Civil Site Visit Report– 1 (Phase 1 & 2)

PROJECT: 1800232 – Rockwood 10

LOCATION: SE Yamhill Street
Portland, OR, 97233

SITE VISIT DATE: July 16, 2021
TIME: 4:30-6:00 PM

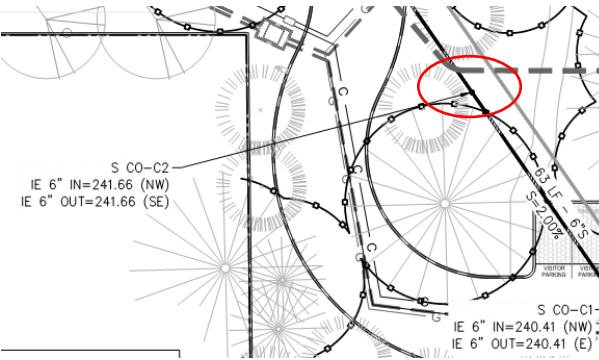
Item No.	Description	Image/Representative Image	Action Required
0	General close out.	Once site is stabilized, remove erosion control BMPs, including inlet protection. Clean out all storm structures without flushing downstream.	
1	Driveway to Phase one paver parking is missing large section of concrete.		Replace missing concrete.
2	Gap between paver and curb.		Clear debris from gap and install portion of pavers to bring parking area flush to curb.
